# 16034G-01A

## S E R V I C E N O T E

### 16034G SMD Test Fixture

**This service note provides the updated part numbers and figures for both RoHS and non-RoHS 16034G SMD Test Fixture**

**Figure 1-1**

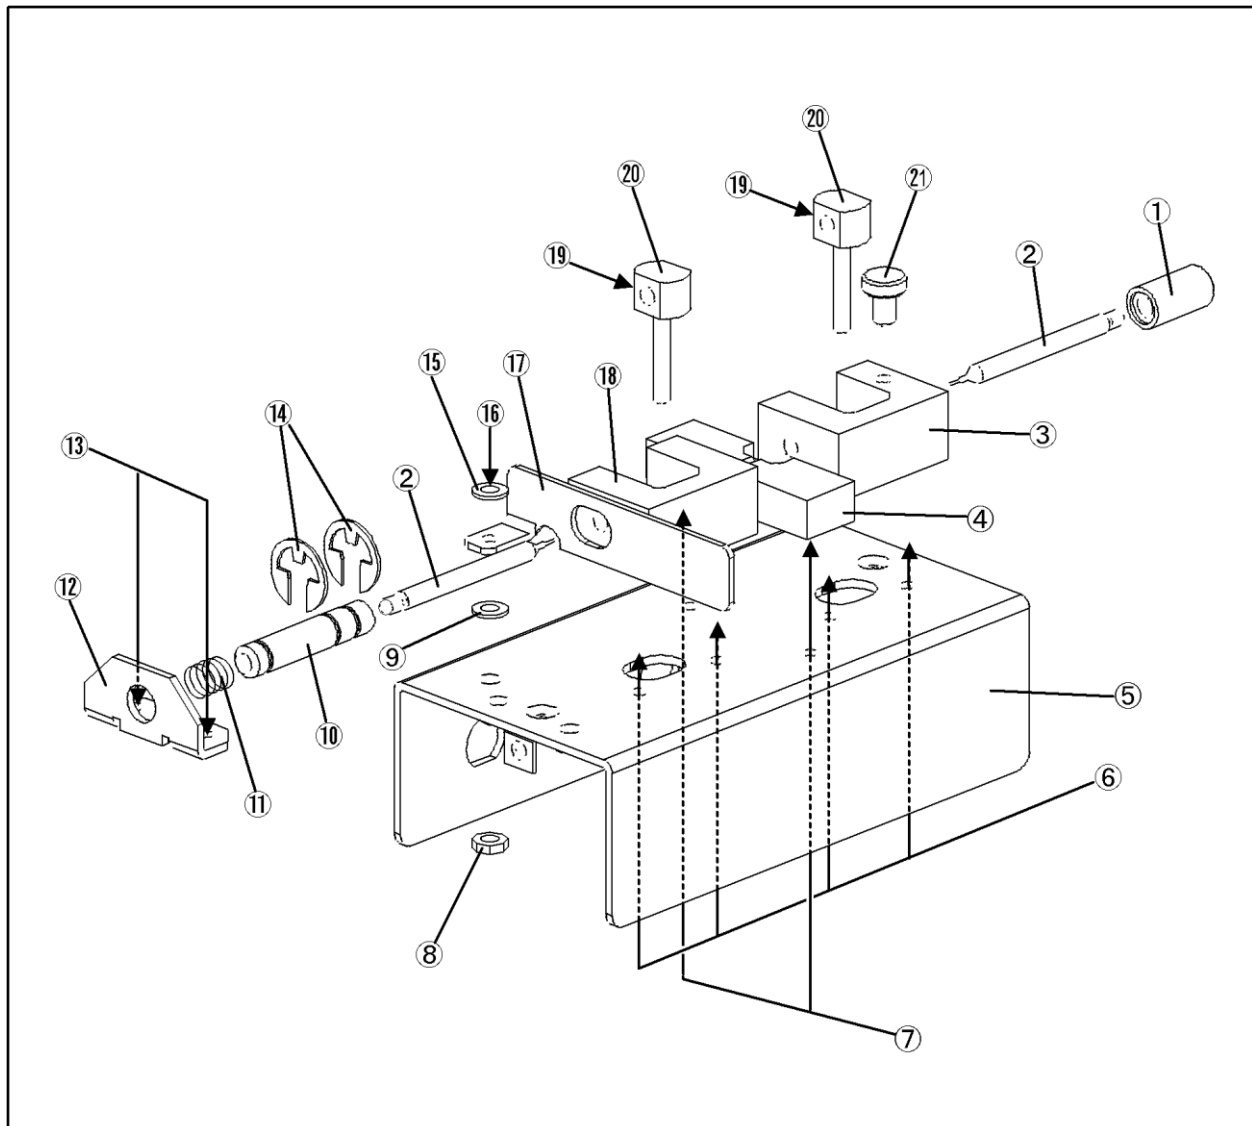
Shown are the supported parts and their respective RoHS compliant replacement support part. RoHS conversion involves with design and dimension change which result in the RoHS support part backward incompatible with non-RoHS 16034G. Special handling is needed while using the RoHS replacement part on non-RoHS 16034G. The original support part number is replaced by the respective "RoHS Compliant Replacement Part". Once the original support part is depleted, please proceed to obtain the RoHS compliant support part. Please refer to figure and table 1-1, 1-2 for the respective replacement part accordingly.

<\*1> Replace all the associated parts marked with <\*1> as they are mutually dependent.

Ref/D	Part Number	Description	Qty.	RoHS Compliant Replacement Part	Description	Qty.
1	16034-25013	KNOB	1	16034-25013	KNOB	1
2	16034-24011 (16034-24051)	ELECTRODE(16034G)	2	16034-24651	ELECTRODE (16034G)	2
3	16034-25011	BLOCK	1	<*1>Set change: 16034-25614 (16034G)	BLOCK (16034G)	1
4	16034-25014	BLOCK (16034G)	1	<*1>Set change: 16034-25614 (16034G)	BLOCK (16034G)	1
5	16034-04011	COVER TOP(16034G)	1	16034-04611	COVER TOP(16034G)	1
6	0515-1550	SCREW	4	0515-0372	SCREW	4
7	0515-1550	SCREW	2	0515-0372	SCREW	2
8	0535-0031	NUT-HEX W/LOCKER	1	0535-0031	NUT-HEX W/LOCKER	1
9	3050-1139	WASHER	1	3050-1139	WASHER	1
10	16034-25015	KNOB	1	16034-25015	KNOB	1
11	16034-08001	SPRING	1	16034-08001	SPRING	1
12	16034-01211	BRACKET	1	16034-01211	BRACKET	1
13	0515-1550	SCREW	2	0515-0372	SCREW	2
14	0510-0083	RETAINER	2	0510-0083	RETAINER	2
15	3050-0891	WASHER	1	3050-0891	WASHER	1
16	0515-0920	SCREW	1	0515-1141	SCREW	1
17	16034-05011	LEVER	1	16034-05011	LEVER	1

18	16034-25012	BLOCK	1	<*1>Set change: 16034-25614 (16034G)	BLOCK (16034G)	1
19	3030-0007	SCREW	2	3030-0007	SCREW	2
20	16034-24012	PLUG	2	16034-24012	PLUG	2
21	16034-24014	SCREW	1	16034-24014	SCREW	1

Figure 1-2

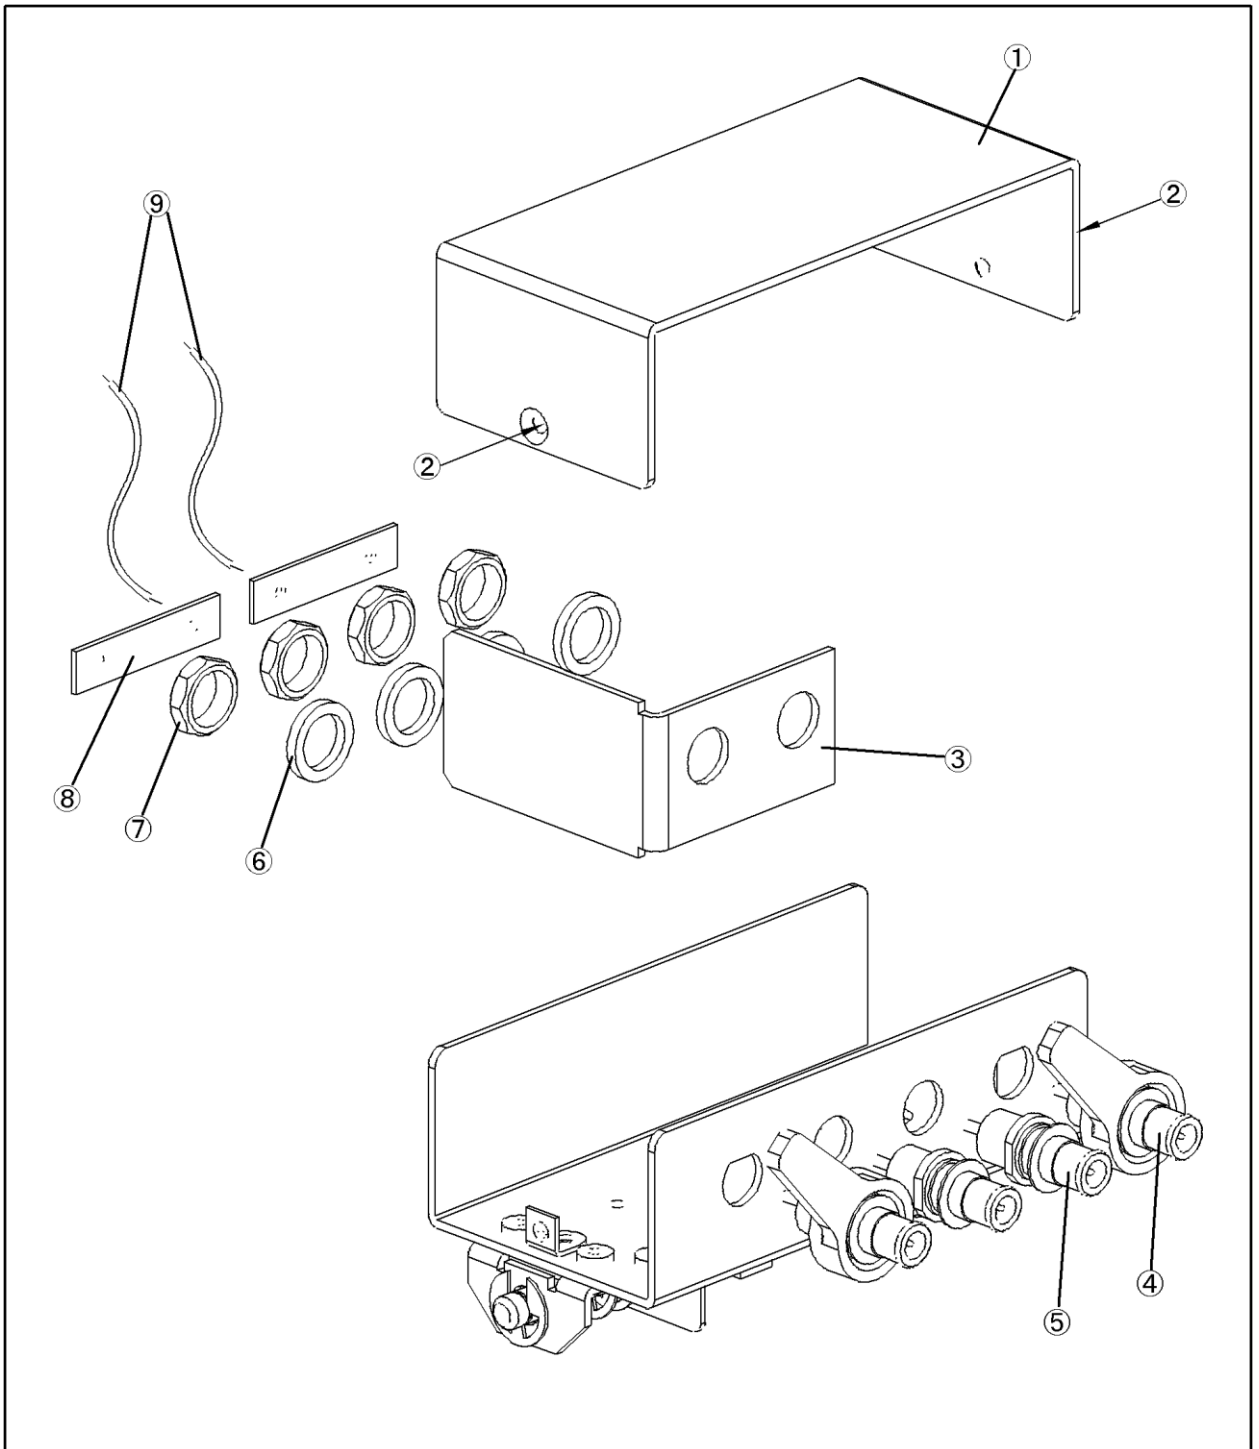
Shown in table 1-1, 1-2 are the original support part and its compatible RoHS replacement part/assembly.

<b>Ref/D</b>	<b>Part Number</b>	<b>Description</b>	<b>Qty.</b>	<b>RoHS Compliant Replacement Part</b>	<b>Description</b>	<b>Qty.</b>
1	16034-04012	COVER BOTTOM	1	16034-04612 (Texture change)	COVER BOTTOM	1
2	0515-0914	SCREW	2	0515-1946	SCREW	2
3	16034-00601 (16034-01212)	PLATE - SHIELD	1	16034-01212	PLATE - SHIELD	1
4	16012-7122	BNC - ASSY	2	5012-8617 (Level color change)	BNC - ASSY	2
5	1250-1798 (16047-60016)	CONNECTOR-BNC	2	5012-8628	CONNECTOR- BNC	2
6	2190-0016	WASHER	4	2190-0016	WASHER	4
7	2950-0043	NUT-HEX-DBL-CHAM	4	2950-0043	NUT-HEX- DBL-CHAM	4
8	16047-00617	PLATE	2	16034-00617 (Do not mix non- RoHS part with RoHS part. Replace both plates with RoHS part if one of the non-RoHS plate is defective)	PLATE	2
9	16034-68021	JUMPER WIRE (2 ea.)	1	16034-68021	JUMPER WIRE (2 ea.)	1

**Figure 2-1**

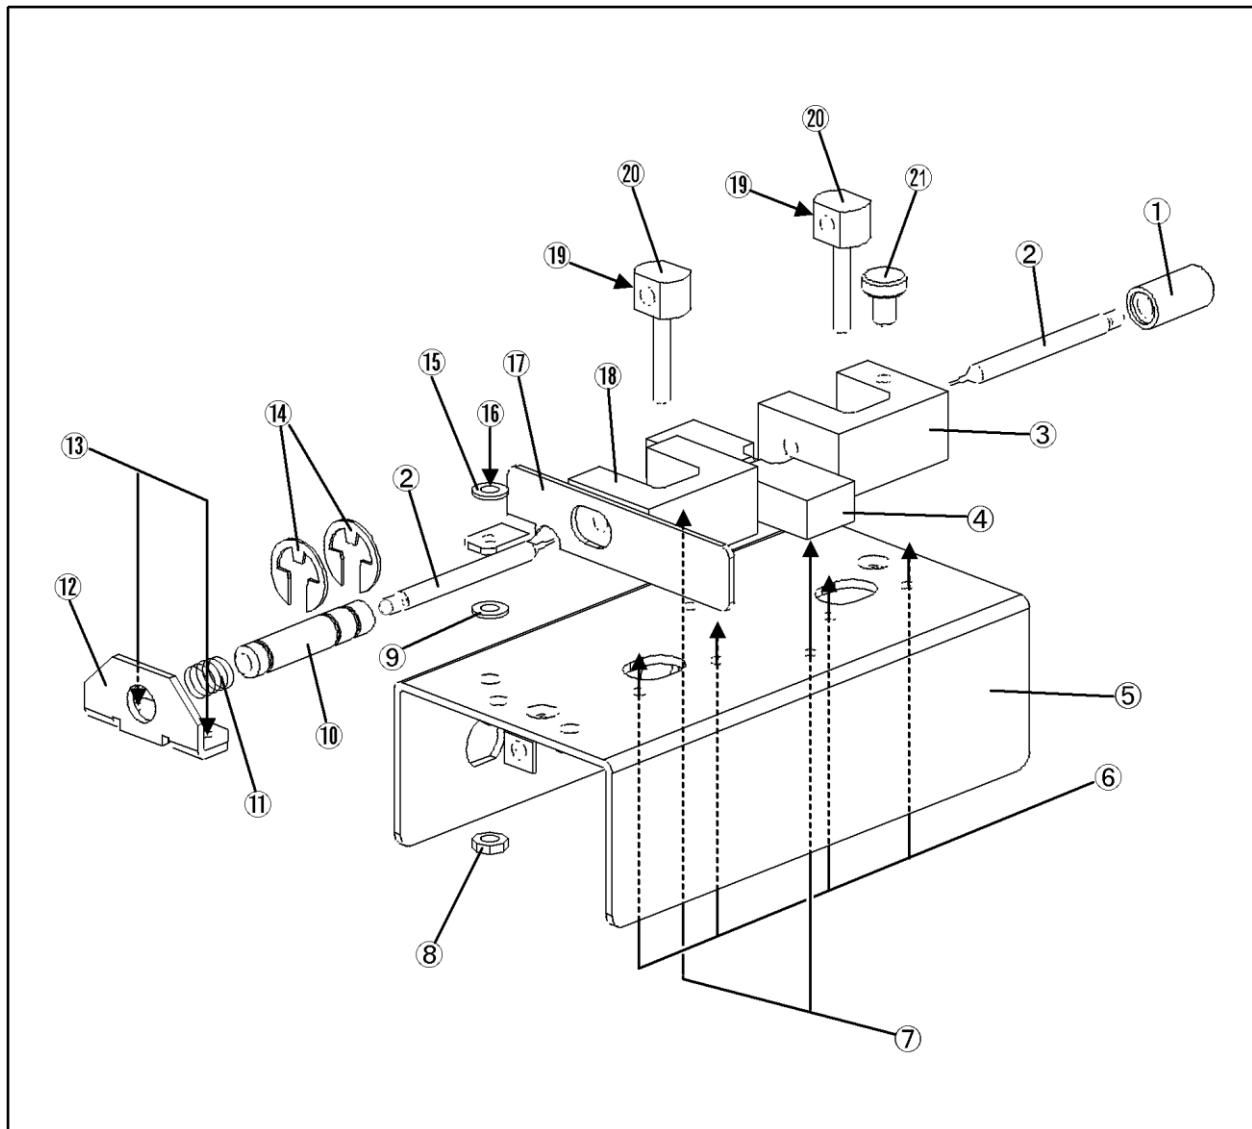
Shown are the support parts for RoHS compliance 16034G SMD Test Fixture. All the listed items are changed at RoHS conversion. Due to limited availability of RoHS compliance station and technical difficulties in RoHS soldering, only parts and support level that do not require RoHS soldering are supported. Shown are the supported RoHS compliance parts for RoHS 16034G SMD Test Fixture.

<b>Ref/D</b>	<b>Description</b>	<b>RoHS Compliant Replacement Part</b>	<b>Qty.</b>
1	KNOB	16034-25013	1
2	ELECTRODE (16034G)	16034-24651	2
8	NUT-HEX W/LOCKER	0535-0031	1
9	WASHER	3050-1139	1
10	KNOB	16034-25015	1
11	SPRING	16034-08001	1
12	BRACKET	16034-01211	1
14	RETAINER	0510-0083	2
15	WASHER	3050-0891	1
16	SCREW	0515-1141	1
17	LEVER	16034-05011	1
19	SCREW	3030-0007	2

Figure 2-2

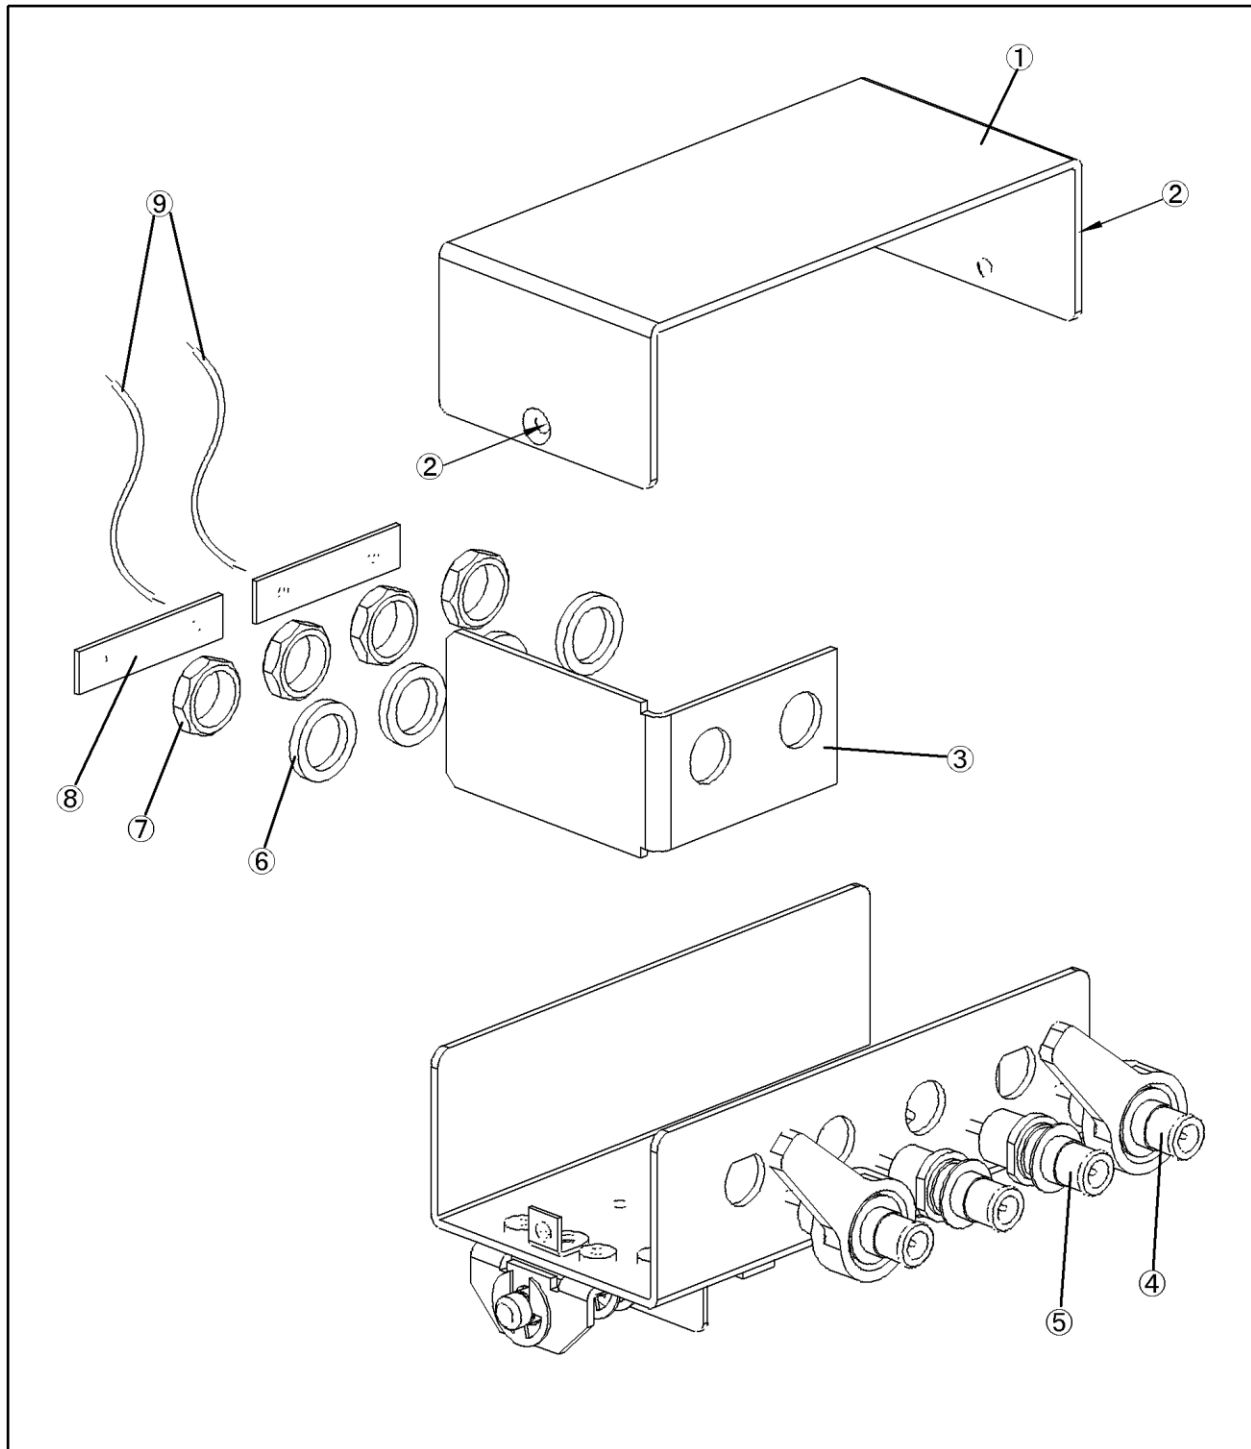
Shown in table 2-1, 2-2 and figure 2-1, 2-2 are the respective support parts for RoHS compliance 16034G unit.

Ref/D	Description	RoHS Compliant Replacement Part	Qty.
1	COVER BOTTOM	16034-04612	1
2	SCREW	0515-1946	2
